Mahoning Creek Hydroelectric Project (FERC No. 12555) License Article 403—Intake Structure Design Plan

INTAKE STRUCTURE DESIGN PLAN

MAHONING CREEK HYDROELECTRIC PROJECT FERC No. 12555

Agency Comments on the Draft Intake Plan

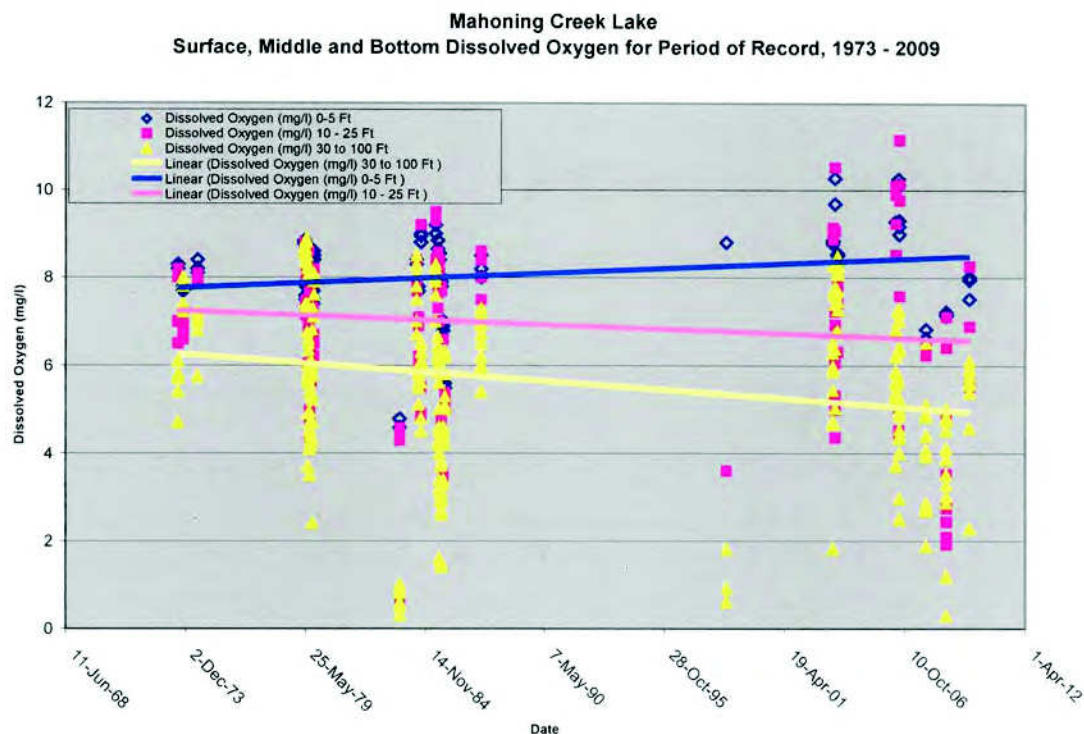
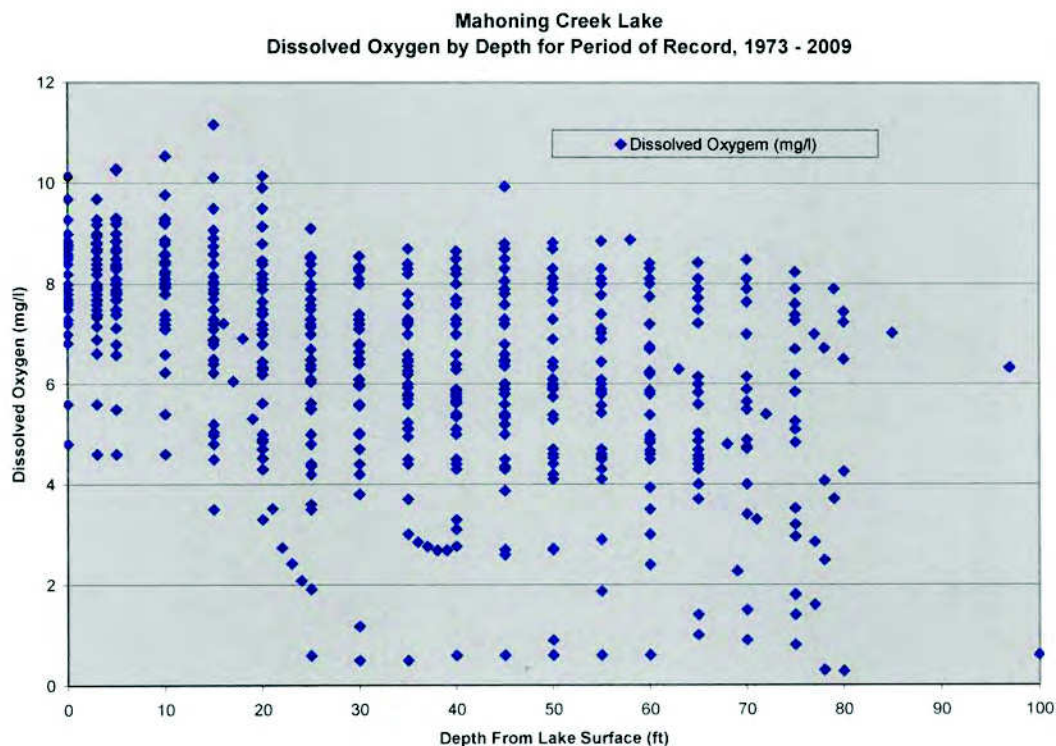
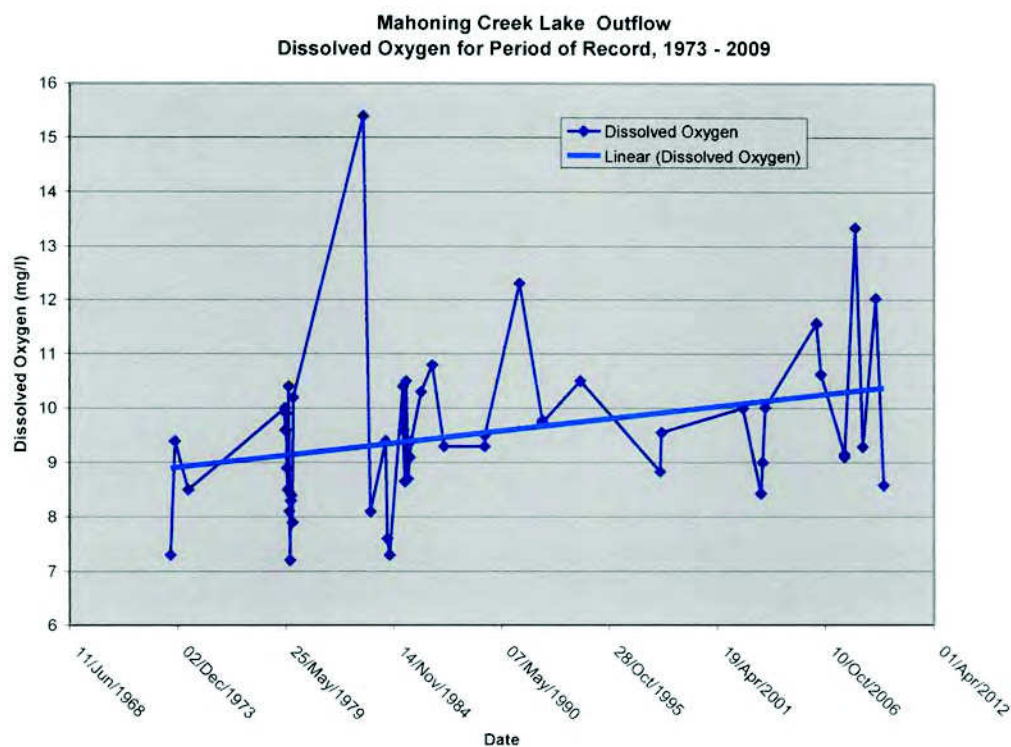
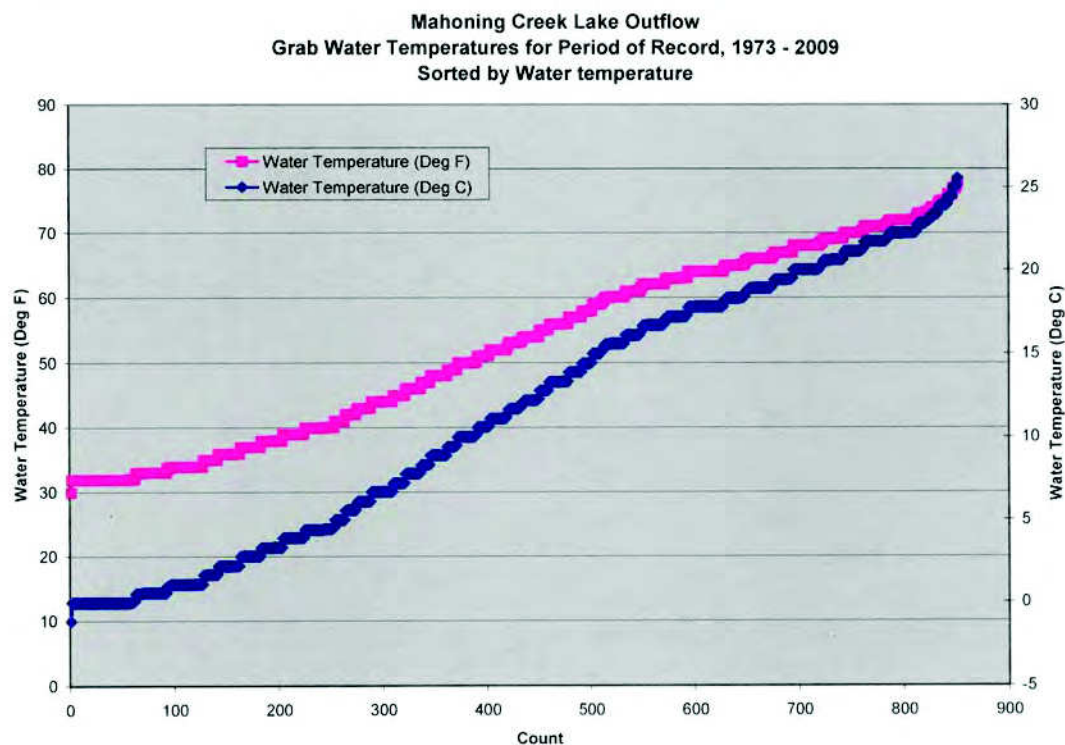
Dissolved oxygen vertical profile data for Mahoning Lake at the deepest location just upstream of the dam for our period of record are presented in Figure 1, and the same data sorted by depth are presented in Figure 2. Outflow dissolved oxygen and water temperature data (sorted by water temperature) are presented in Exhibits 3 and 4, respectively.

As can be seen in Figures 1 and 2, lake dissolved oxygen levels are generally > 5 mg/l at depths < 25 feet although there is a general trend towards decreasing DO levels in the lake hypolimnion (30 - 50 ft) over the period of record. The average lake surface DO (0 to 5 ft) is 8.9 mg/l, the average mid-depth DO (10 to 25 ft) is 7.0 mg/l, and the average lake bottom DO (30 to 100 ft) is 5.7 mg/l. As can be seen in Figure 3, the lowest outflow DO reading for the entire period of record was 7.2 mg/l in 1979, and these data show a general increasing trend. Figure 4 demonstrates that outflow water temperatures do not exceed 80 Degrees F.

Figure 5

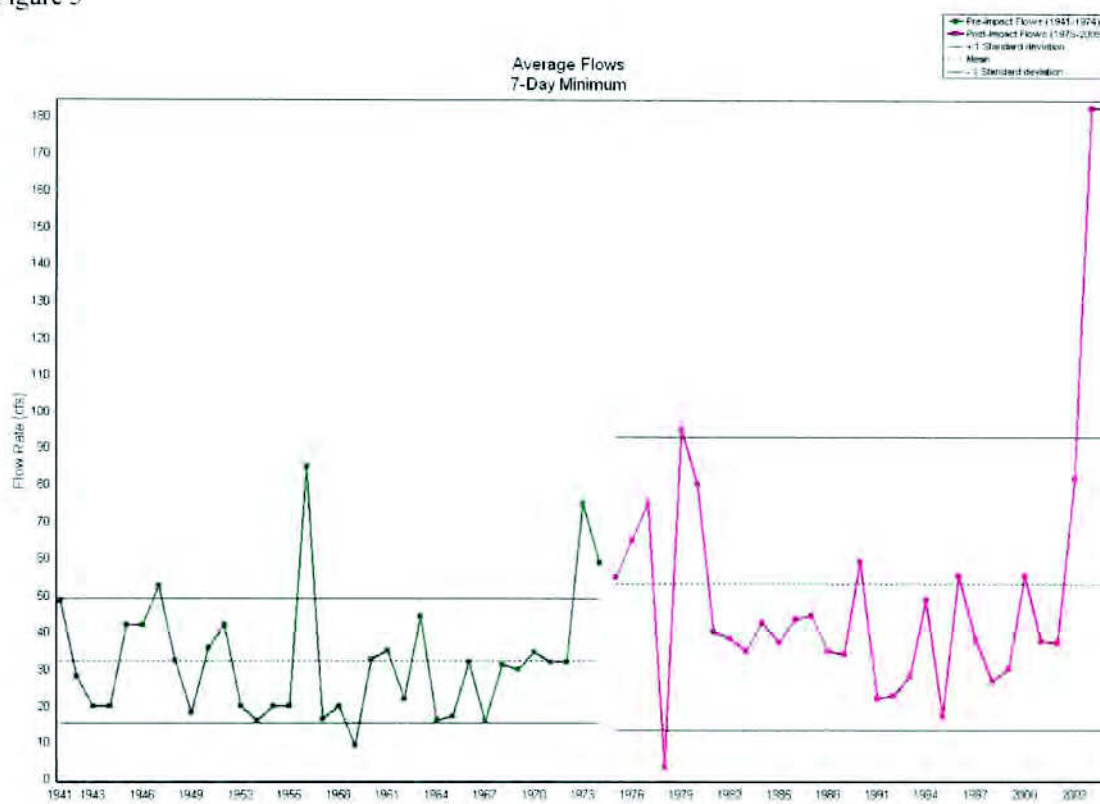
interpretation of the meaning of Q7-10; it appears that this concept is being interpreted differently by MCHC and the Corps. Page 19 of the EA includes a footnote defining Q7-10 as “the lowest flow which has occurred on a given stream reach for seven consecutive days over the previous 10-year period of record”; the USGS defines it as “the average minimum streamflow expected for seven consecutive days once every ten years”; and the EPA defines it as “the seven-day, consecutive low flow with a ten-year return frequency; the lowest stream flow for seven consecutive days that would be expected to occur once in ten years”. The differences in wording may be small, but we would like to stress that Q7-10 is not the 7-day low flow from the previous ten years and MCHC’s reference to a ten-year period ending on September 30, 2008 is in error since the Q7-10 is not based on a specific ten-year period.

The use of the calculated Q7-10 as a bypass flow is not appropriate because it does not address seasonal requirements or impacts of a permanent low flow on water quality and aquatic life in the stilling basin. As we commented in our review of the Application for New License, the proposed 30 cfs bypass flow will not adequately protect stilling basin water quality and aquatic life; will increase lake sedimentation since hypolimnetic releases will be reduced; will increase sedimentation in the stilling basin and degrade stony bottom habitat; and is too low to minimize impacts of a higher intake elevation on lake and downstream water temperatures. Therefore, we will require that the Operations
